To	Regulatory Sub-committee
From	Summer Salmon Senior Planner
Date	22 November 2017
Approved By	Ella Makin – Consents Team Leader
DWS Document Set #	
Application	SUB0009/17
Report Title	Section 42A Report on a publicly notified resource consent application by Te Kauwhata Land Limited to undertake a seven-staged subdivision to create 163 residential lots, nine lots to vest as road, 16 access lots, two lots for local purpose reserves for drainage and one lot for recreation reserve; and, concurrent land use consent to undertake earthworks and construct four show homes (commercial activities) within consented lots and blanket consent to enable different building coverage and impervious surfaces within consented lots.

The subdivision application seeks to undertake a subdivision to create 163 residential lots within seven stages within the Te Kauwhata West Living Zone. Lots will vary in size from 569m² to 962m². In addition to the residential lots, 16 jointly owned access lots (JOAL's), a recreation reserve to vest, two drainage reserves to vest and roads to vest will also be created. A summary of each stage is shown in the table below.

Image 4 – Silverspur Retaining Wall Plan

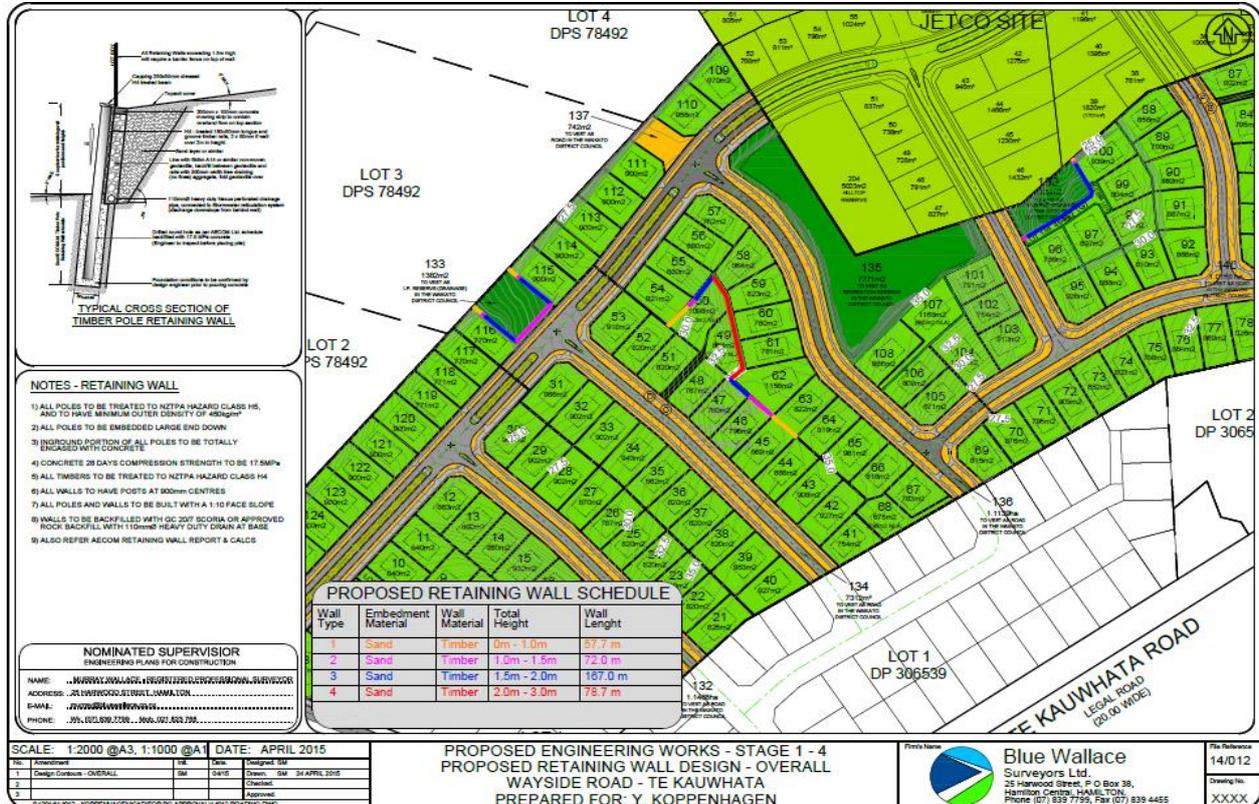
- The Retaining Wall Plans provided as part of the SS application do not show any retaining walls in the vicinity of the knoll or along the Country Living Zone (CLZ) boundary (see SS vs TKL Retaining Wall Plans in Figures 7-9 below). It was only at detailed design stage that it was identified that numerous retaining walls would be required, some up to 8m in height.

- (9) Overall, the proposal is not supported for the following reasons:
 - Visual effects of retaining walls on Countryside Living boundary;
 - Visual effects of the knoll/Hilltop Reserve Design 5A from viewpoints outside the subdivision;

- (4) It is recommended that retaining walls along the CLZ boundary either be screened with vegetative planting buffers, or preferably removed with the use of planted batters.

Image 8: Indicative roading layout (in red) vs proposed TKL roading layout

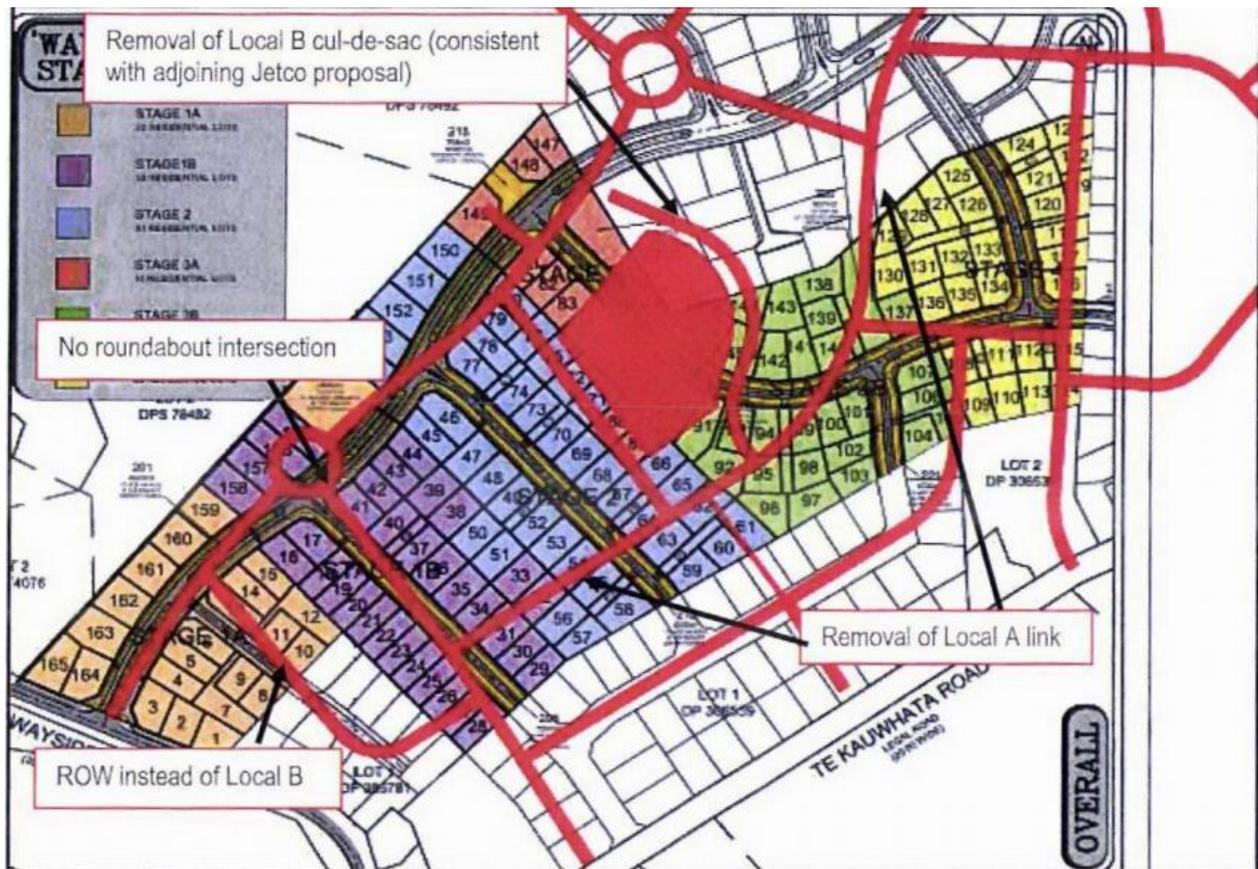
The TKL road layout still includes most of the SS changes but rather than creating a private road parallel to Wayside Road (as consented under SS) the proposal now seeks to create a reduced width public road which connects the subject site to the neighbouring property. The TKL proposal also seeks to further deviate from the indicative roading layout by removing a 'Local B' road which travels north-south through the Jetco and subject site. The main collector road carriageway is also slightly modified to better follow the natural contour of the land. Image 8 below shows the proposed roading layout vs the indicative roading layout as shown within the District Plan.

For the same reasons detailed within the SS consent, I consider the effects associated with creating a roading layout the same as the SS proposal are considered to be no more than minor on the environment. The SS planners report is provided for reference and details the reasons for allowing the departures from the Structure Plan roading layout.

Image 11 - Te Kauwhata West Living Zone Stage One Staging Plan

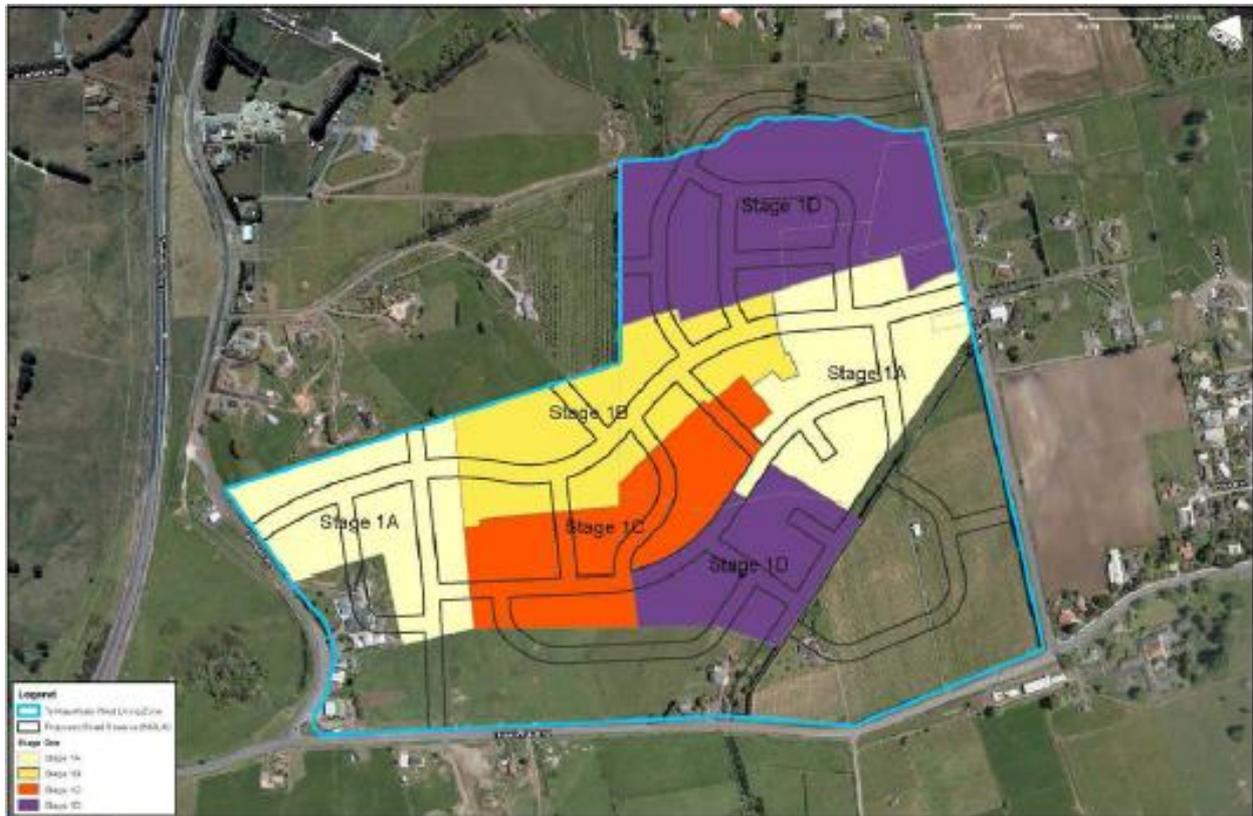
The staging of the proposed subdivision (see Image 1 above) does not align with the District Plan sub-staging plan in Image 11 above.
